BODE RAINIER

SDCI # 3038509-LU MASTER USE PERMIT

S38 BODE RAINIER
RESIDENTIAL APARTMENT

This is a consolidated summary of all review comments for this review cycle. Please respond to each comment and resubmit this as a response plan set along with your new, updated plans.

LEVEL 2 FLOOR
PLAN

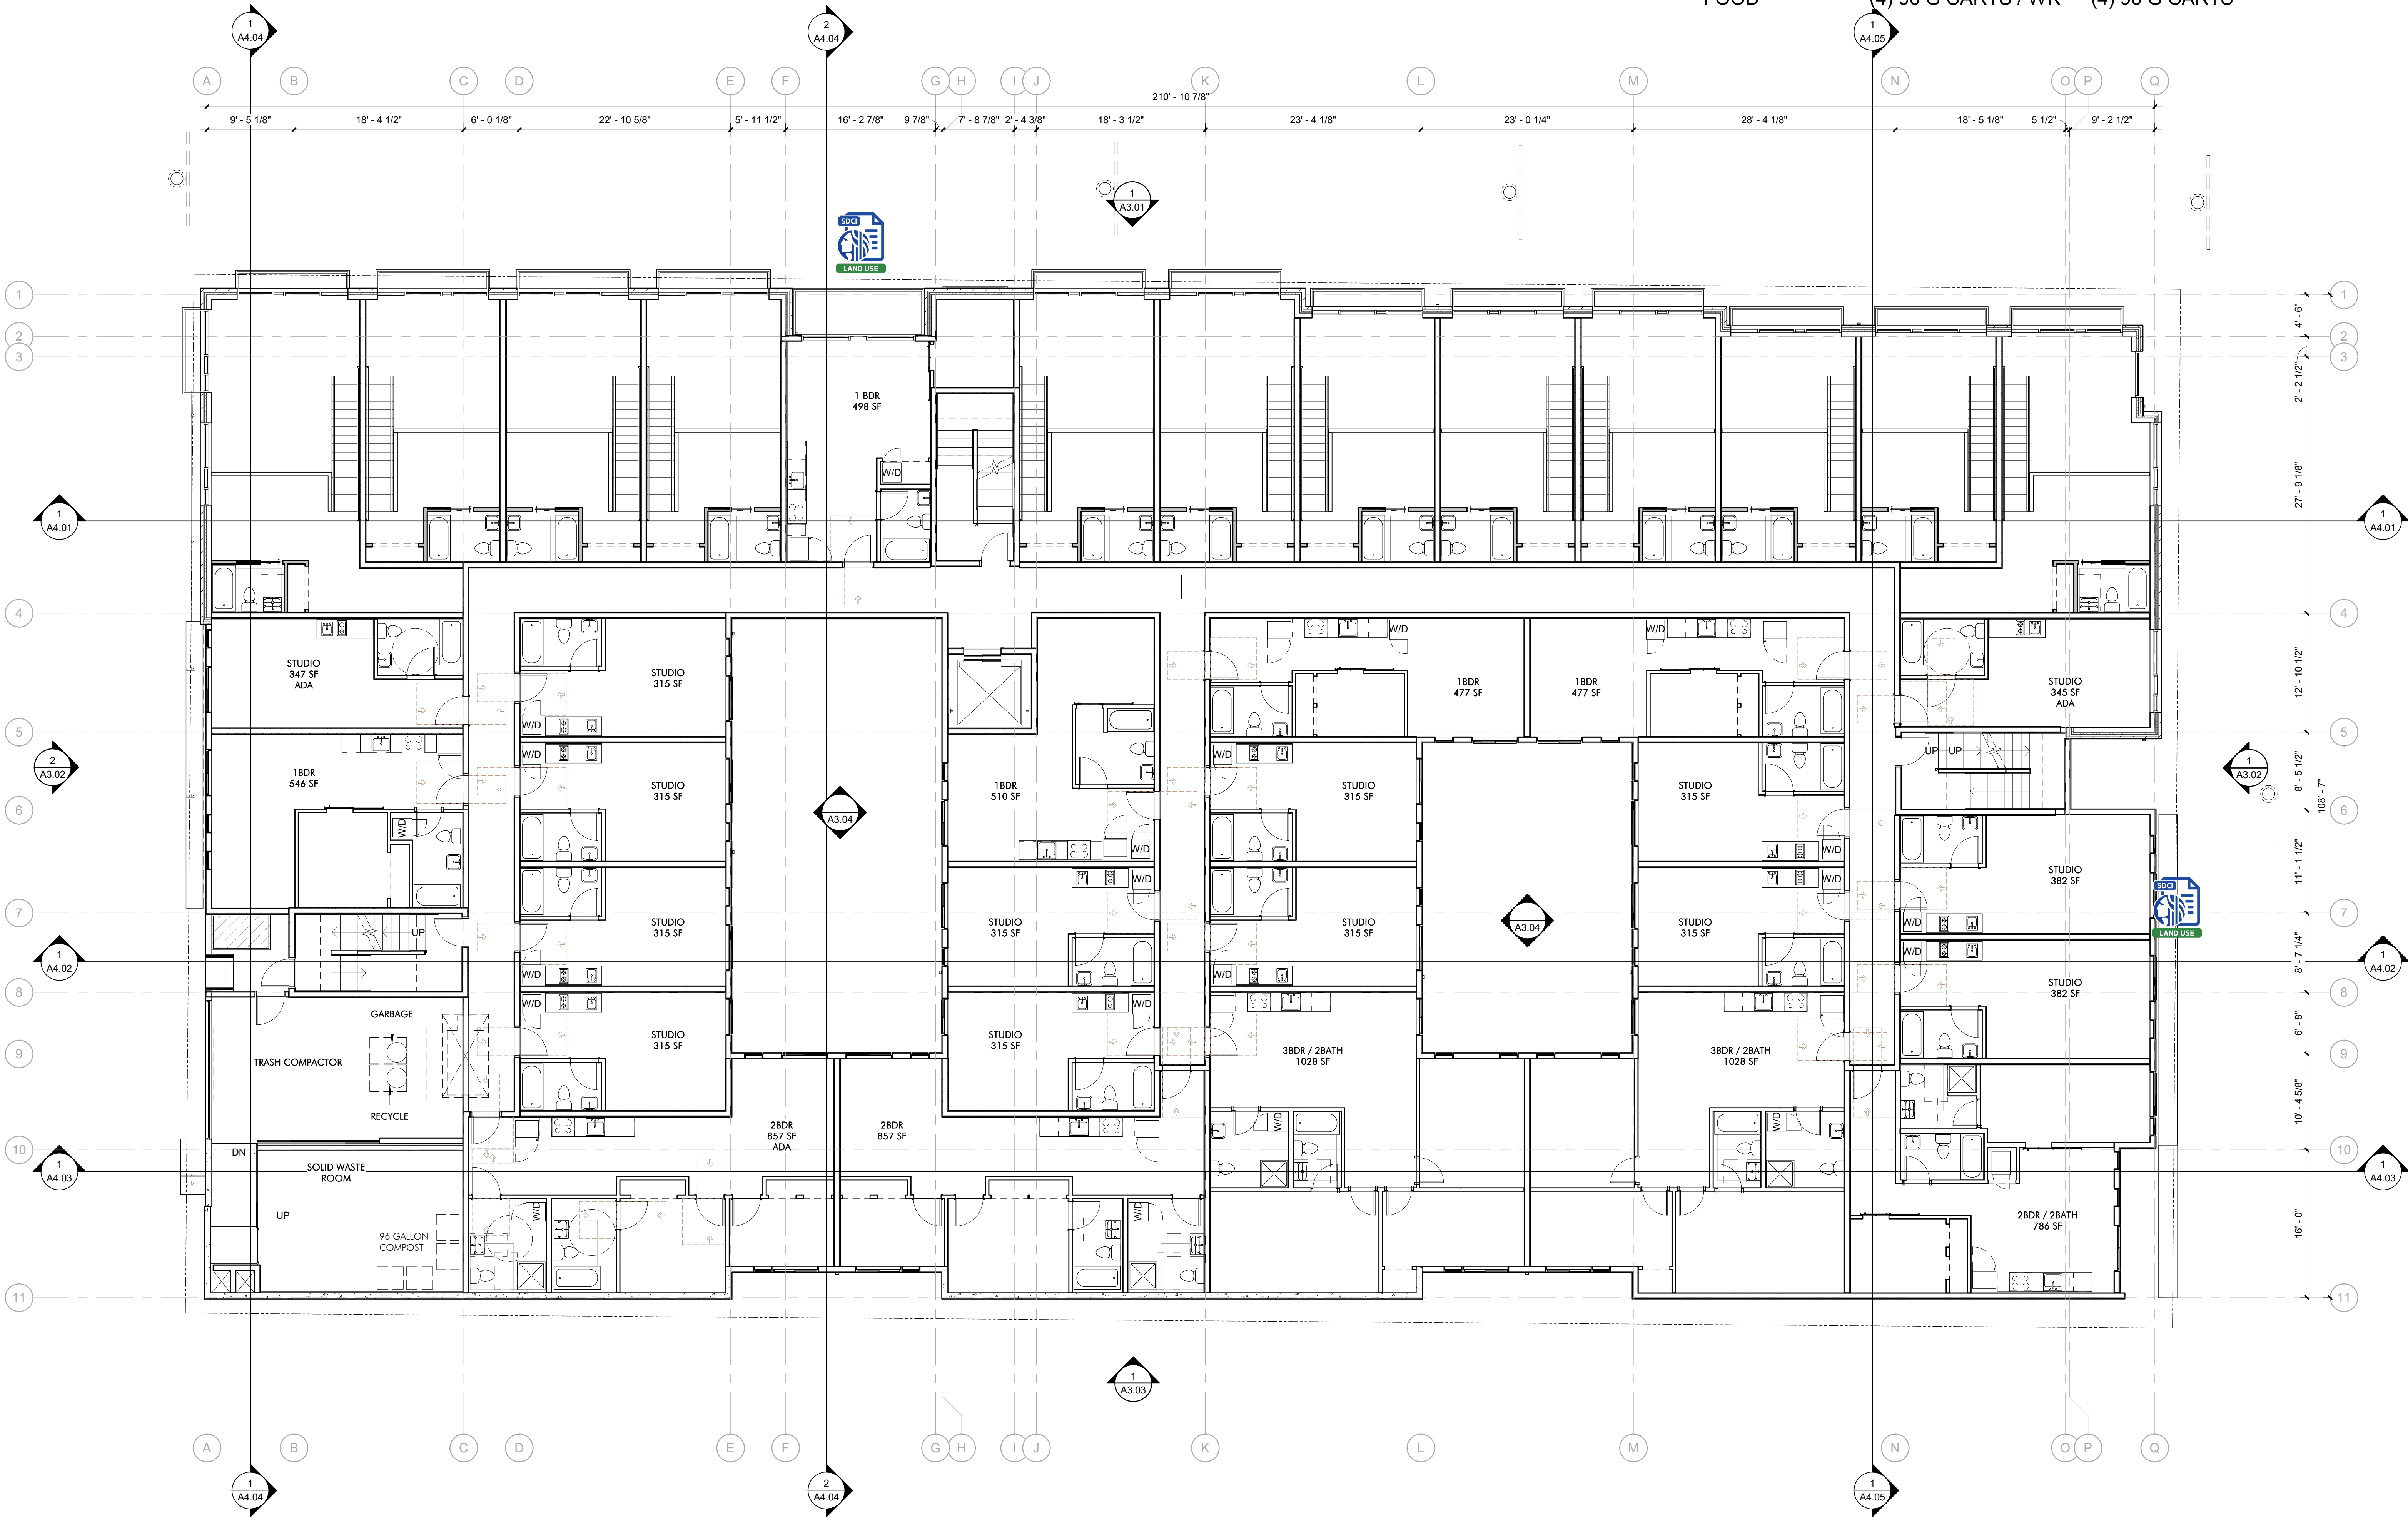
The width of this recess has been significantly been reduced since EDG 2 from 22'-8" down to 14'-6". Provide a rational how this reduced width responds to guidance and creates a better modulated mass.

These three units were shown recessed at EDG 2. Provide rational for the change.

LEVEL 3 FLOOR PLAN

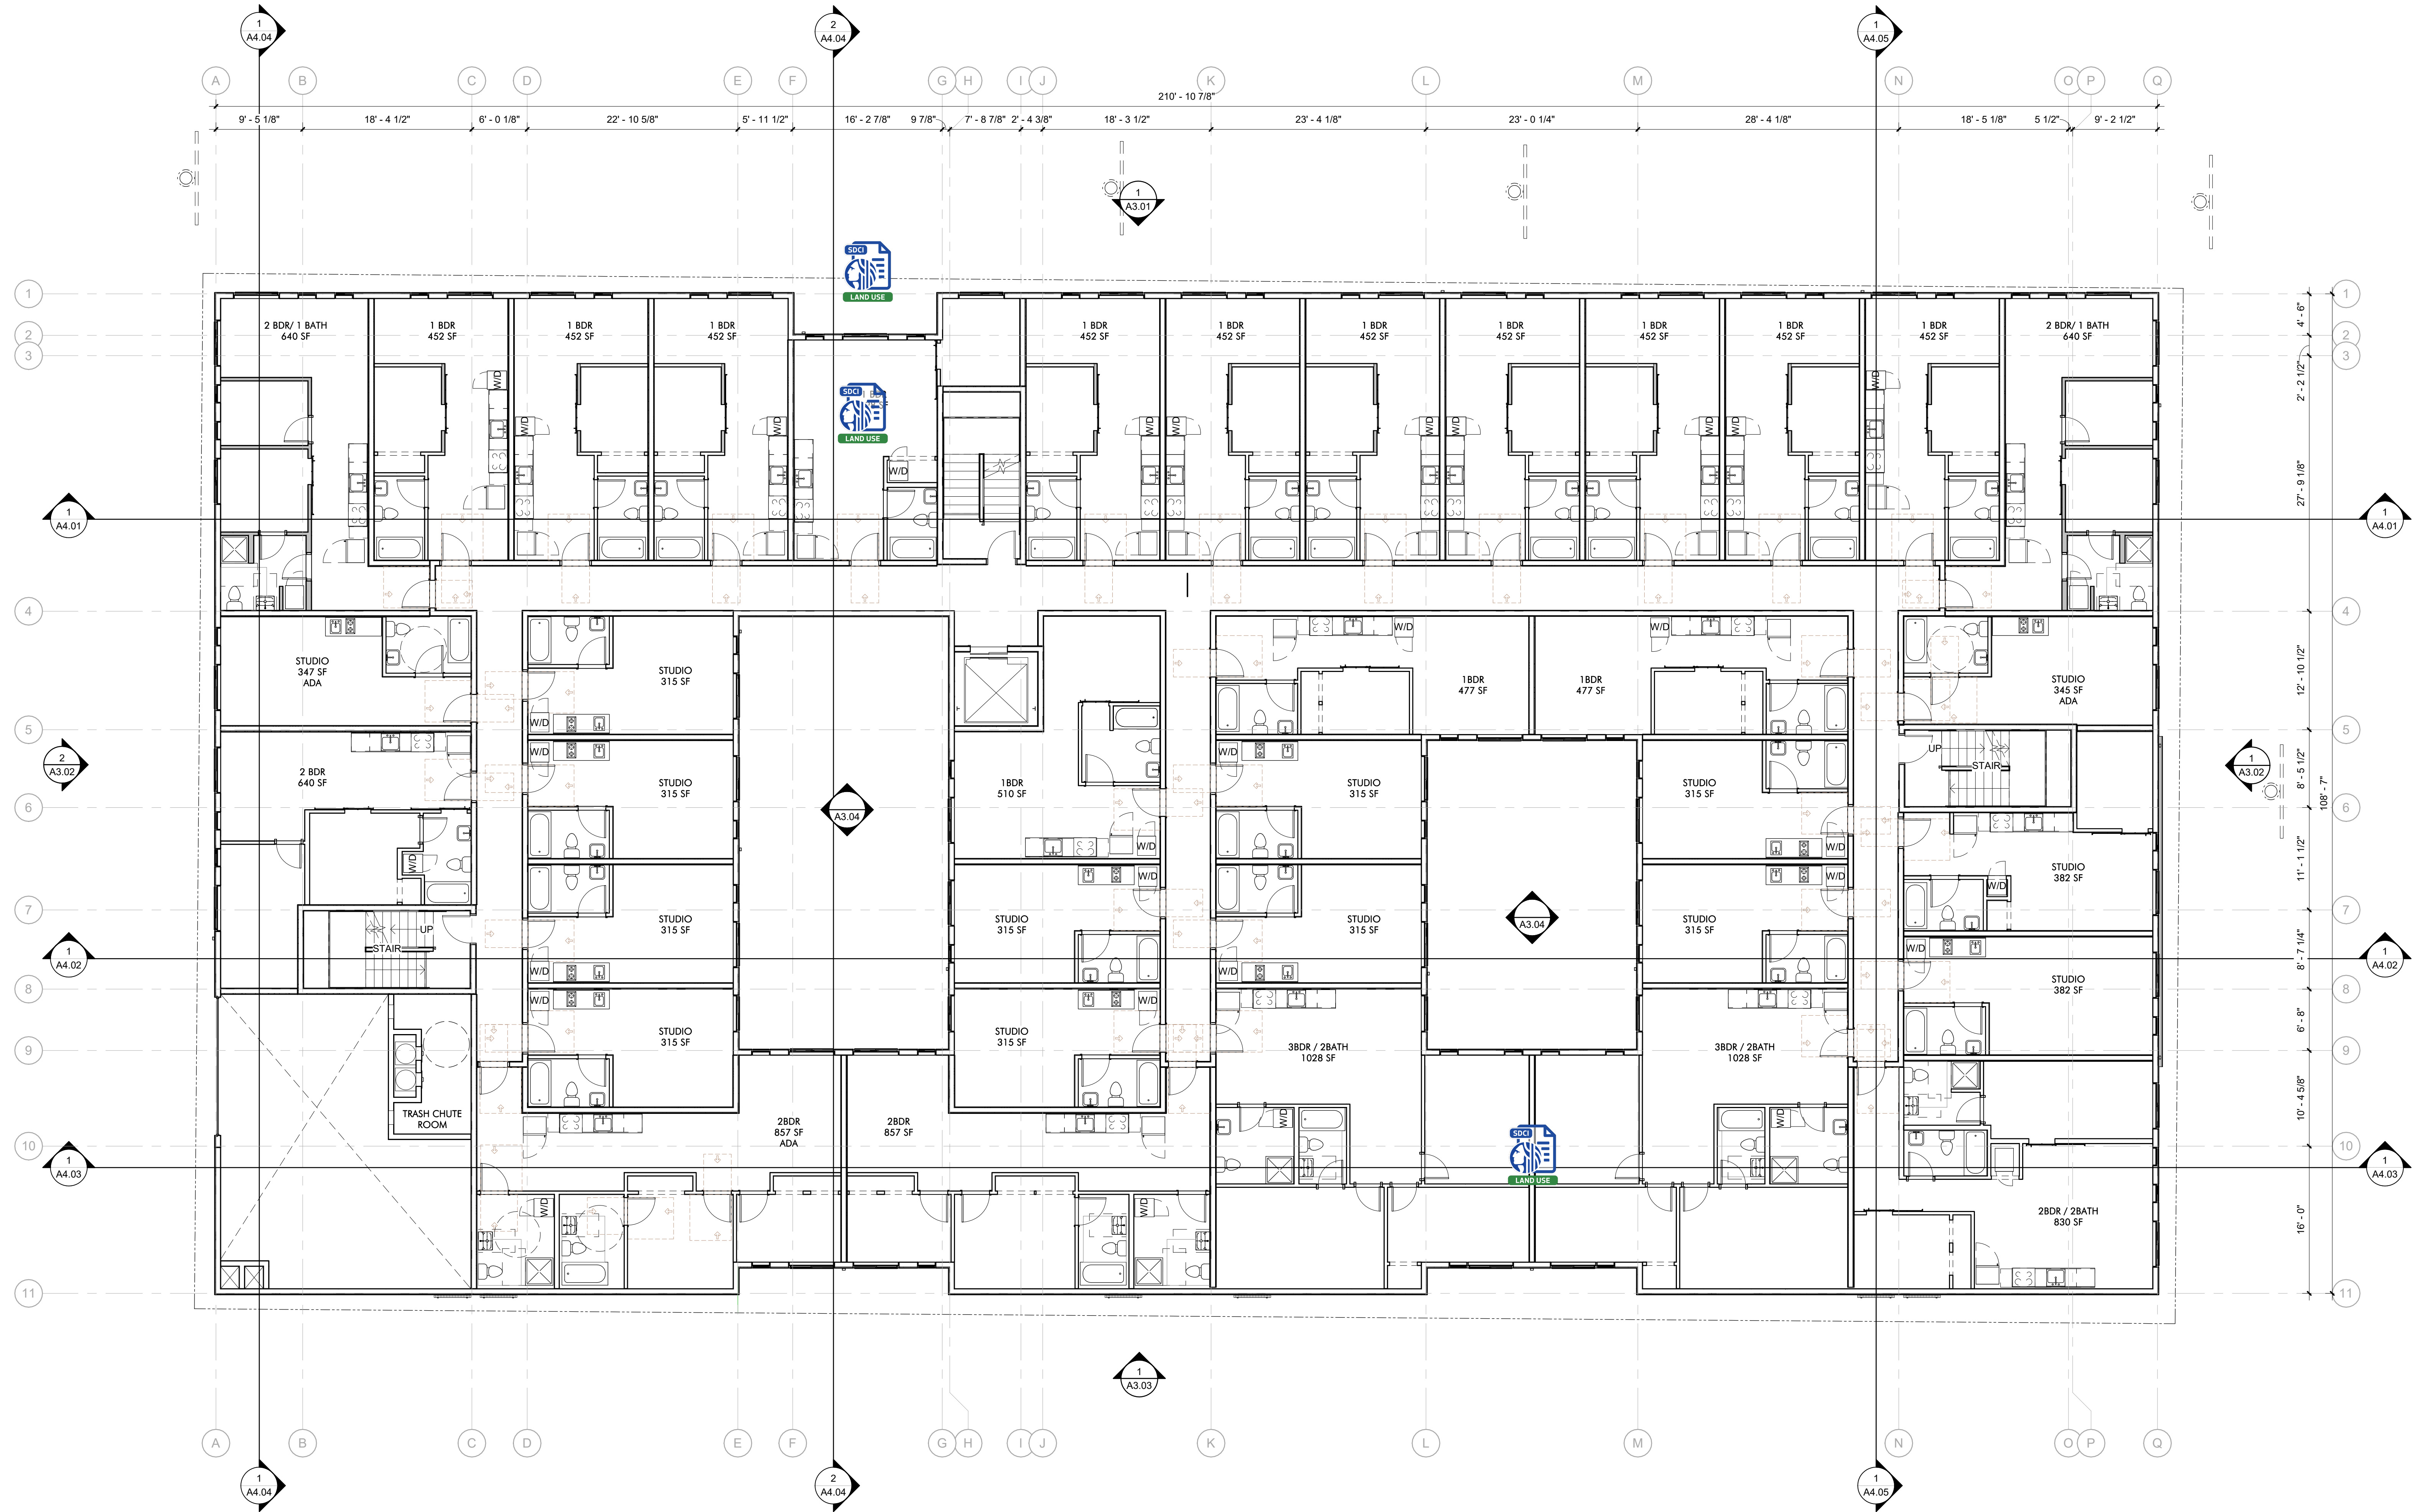
This area was not filled in at EDG 2 and has since been filled in with units. This fundamentally changes the perceived height, bulk, and scale of the building. Provide a rational for this change or remove the units in this location.

This area was not filled in at EDG 2 and has since been filled in with units. This fundamentally changes the perceived height, bulk, and scale of the building. Provide a rational for this change or remove the units in this location.

The width of this recess has been significantly been reduced since EDG 2 from 22'-8" down to 14'-6". Provide a rational how this reduced width responds to guidance and creates a better modulated mass.
